ADDENDUM NO. 3:

Date: February 10, 2026
 Project: Verbena HS Gym
 DCM# 2025629
 WSM# 25-032

Owner: Chilton County Board of Education
 Architect: Ward Scott Morris Architecture, Inc.

A301

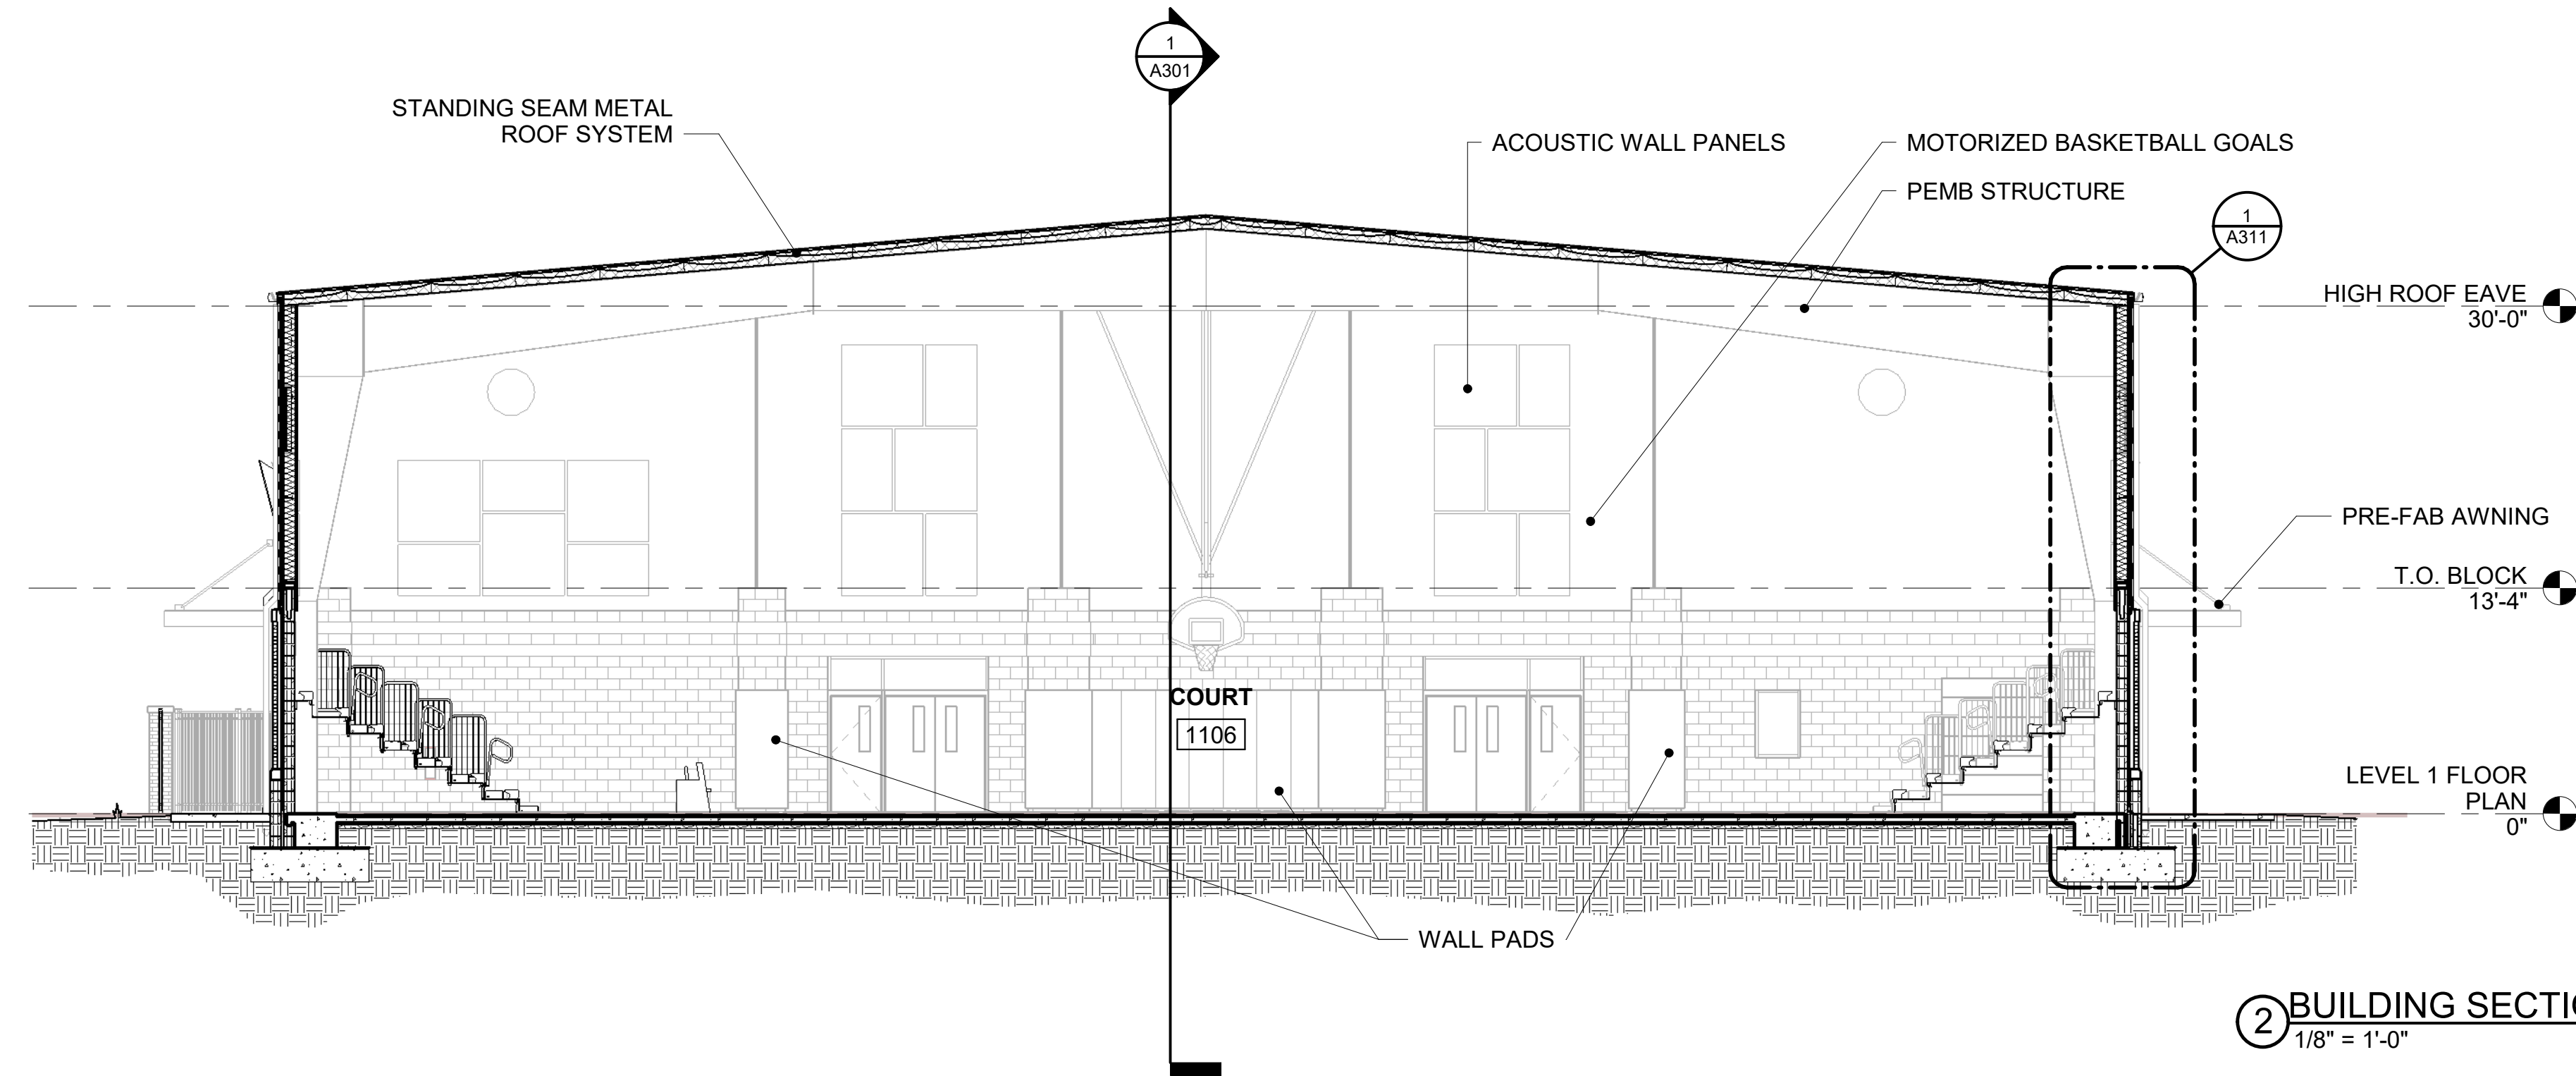
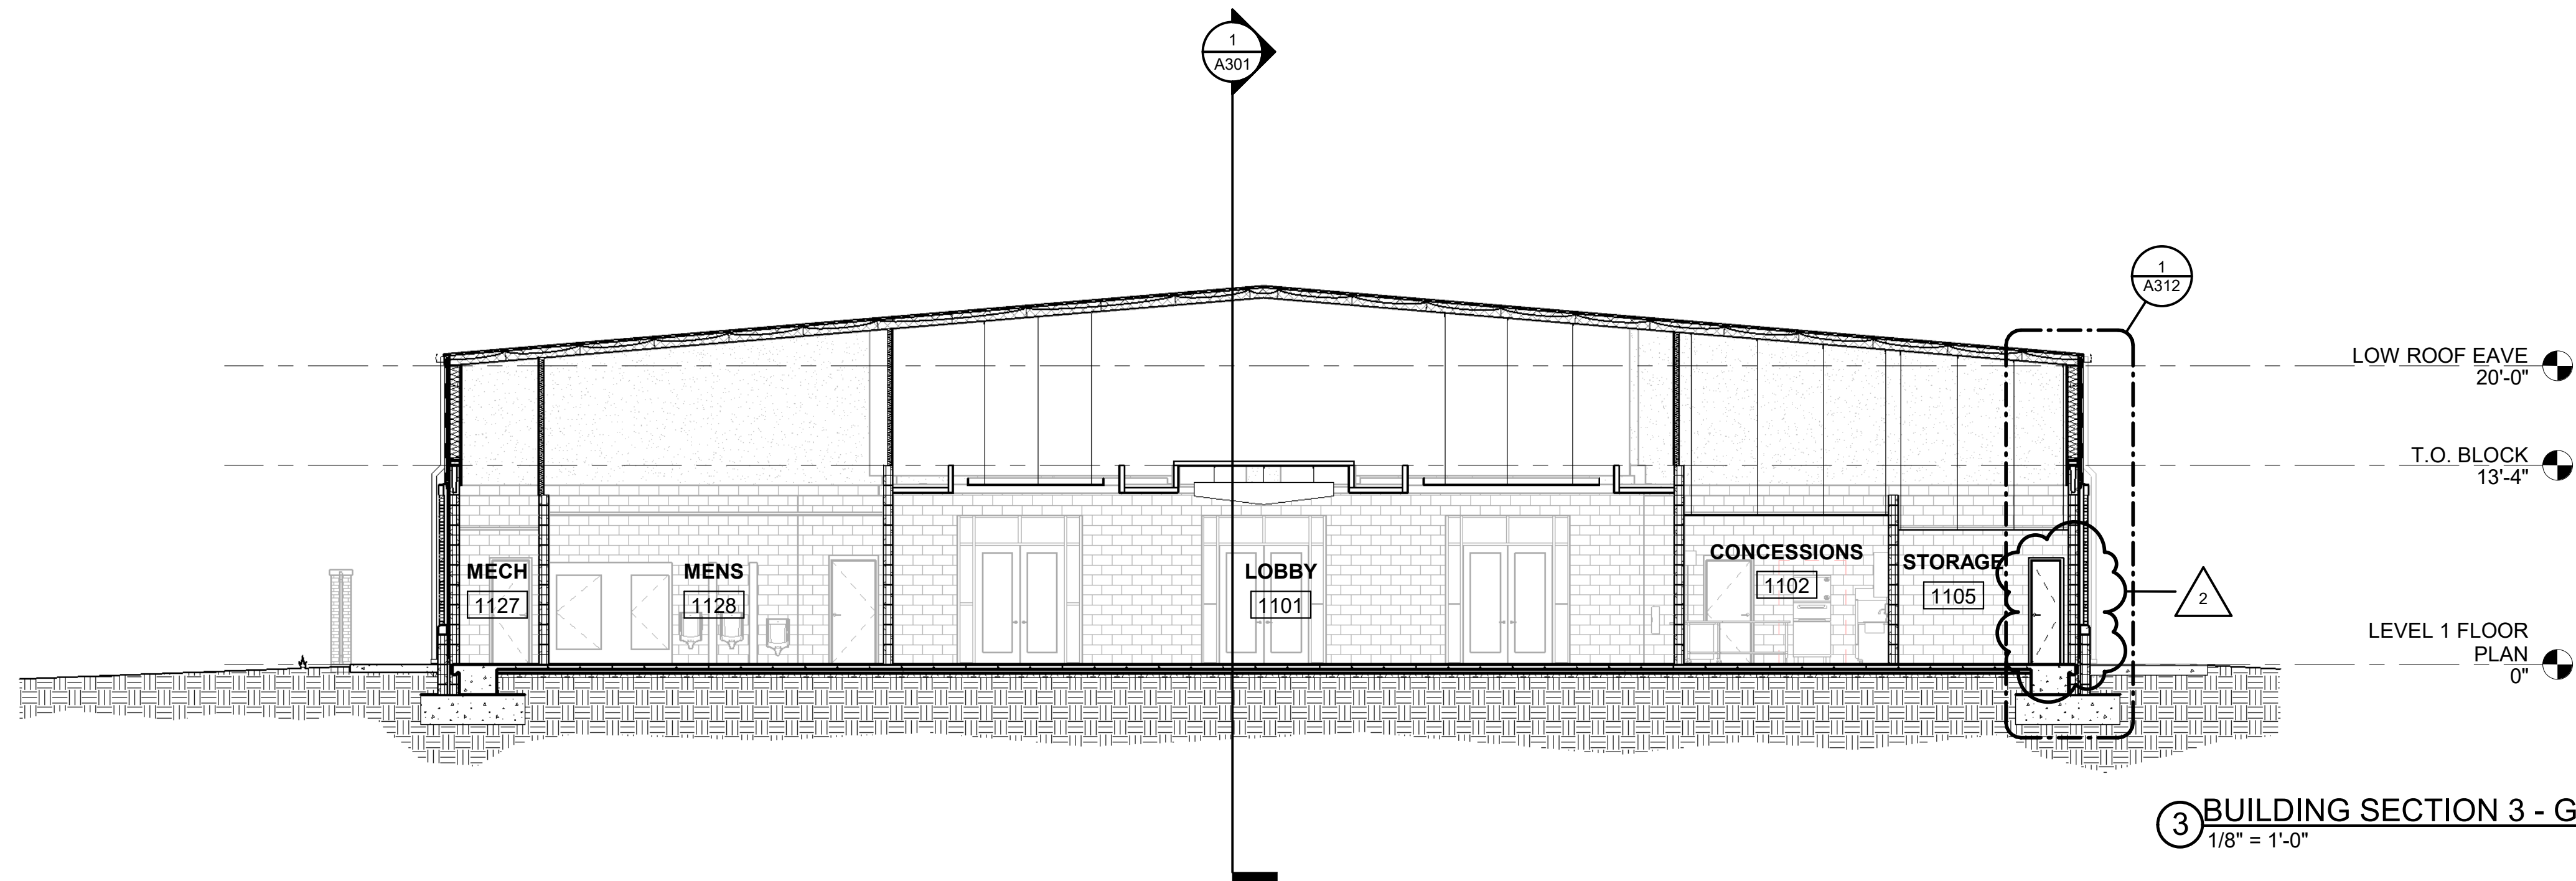
- A. Structural Sheets S000, S100, S500; Refer to attached revised drawings for wall relocation between Rooms #1104 and #1105.
- B. Sheets A002; Refer to attached revised drawing for door and glazing changes.
- C. Sheets A101, A111 and A301; Refer to attached revised drawings for wall relocation and door added between Rooms #1104 and #1105.
- D. Sheet A103; Kitchen Equipment Schedule; change R/F model numbers to TS-24F-FLX-HC, TS-23F-FLX-HC, all stainless-steel exterior.
- E. Sheet A103 and A111; Addendum No. 1 item 1.3.H; R/F-2; change this model number to TS-49FG-FLX-HC-FGD01, all stainless-steel exterior.
